### ZONING CHANGE, NEIGHBORHOOD PLAN AMENDMENT, AND ORDINANCE AMENDMENT REVIEW SHEET

CASE NUMBERS: East Riverside Corridor Regulating Plan

Code Amendment Case Number: C20-2011-003

# COMMENTS RE 9/14/12 DRAFT ERC REGULATING PLAN - POST-9/25 MEETING

Figure 1-5: East Riverside Corridor Collector Street Map

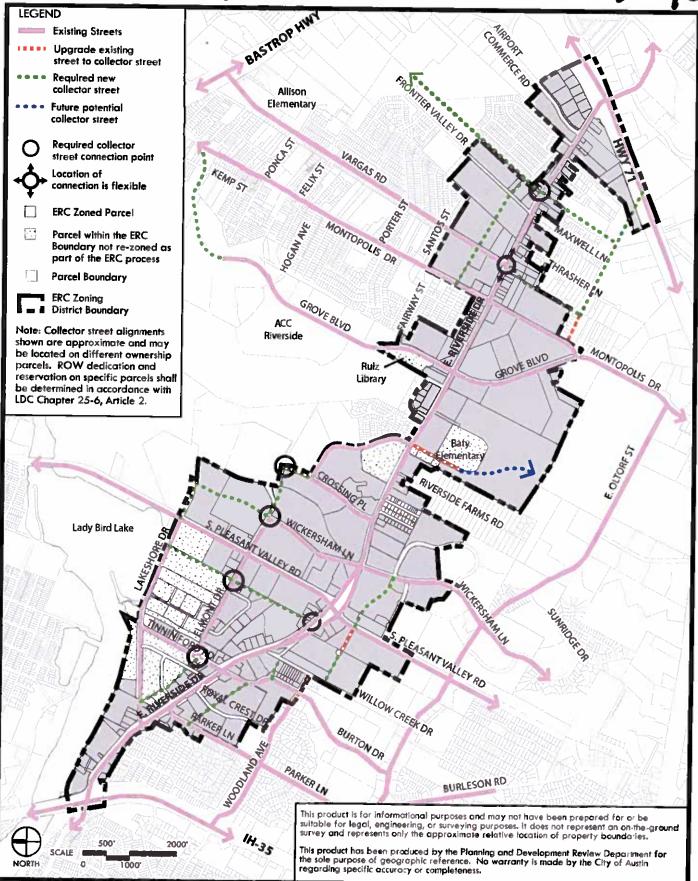
Item	Page	Section	Relates to	Issue	Solution
9	15	Figure 1-5	Collector Street Map	Easternmost collector located parallel Consider moving collector north to prand north of E. Riverside Drive is located for greater distance from E. Riverside	Consider moving collector north to provide for greater distance from E. Riverside
				too close to E. Kiverside Drive.	Drive. This collector will be heavily used as it connects all development from Montopolis and east to Frontier Valley.
7	15	Figure 1-5	Collector Street Map	Westernmost collector located parallel and north of E. Riverside Drive is unlikely location for collector roadway due to proximity to E. Riverside Drive.	Consider relocating further north or eliminating. The triangle roadway system of E. Riverside, Tinnin Ford and Lakeshore is ample. OR consider downgrading to alley for commercial services along E. Riverside.
∞	16	Figure 1-6	Нир Мар	HUB boundaries are not large enough to reflect greater density needs versus lower densities actually constructed.	HUB boundaries are not large enough to Enfrarge HUB boundaries to 1/2 mile and reflect greater density needs versus increase subdistrict boundaries lower densities actually constructed.

Figure 1-7: East Riverside Corridor Height Map

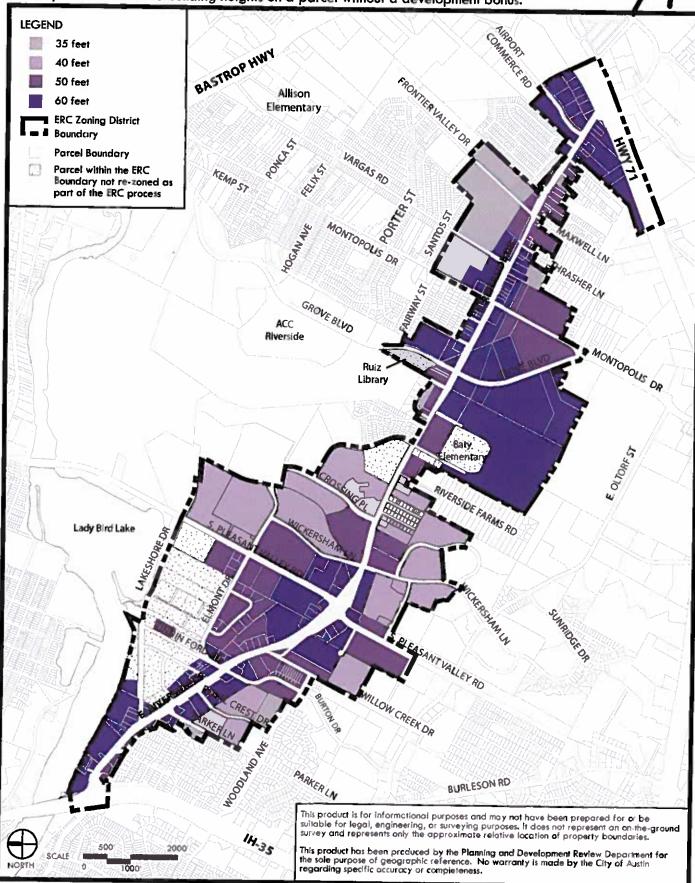
6	17	Figure 1-7	Height Map	35' is not enough height to gain enough Modify all districts to a 40' minimum density to help create transit height.	Modify all districts to a 40' minimum height.
10	19-23	Figures 1-9 thru 1-13	Subdistrict Development Regulations	Environmental maximum impervious cover is coded by LDC 25-8, not ECM.	Change citation to LDC 25-8 .
11	20 & 21	20 & 21 Figures 1-10 & 1-11	Subdistrict Development Regulations	Allows for 1 story development in HUB bouundaries.	Modify HUB boundary development under all subdistricts to be 2-story minimum.
12	23	Figure 1-13	NR Subdistrict Development Regulations	Land uses of SF detached, SF attached, Modify to remove the lowest commo duplex and townhome does not provide denominator developments from the for densities	Modify to remove the lowest common denominator developments from the corridor boundary. OR eliminate this
13	27 .	2.3.4.E	Subdistrict Types		Same as above.
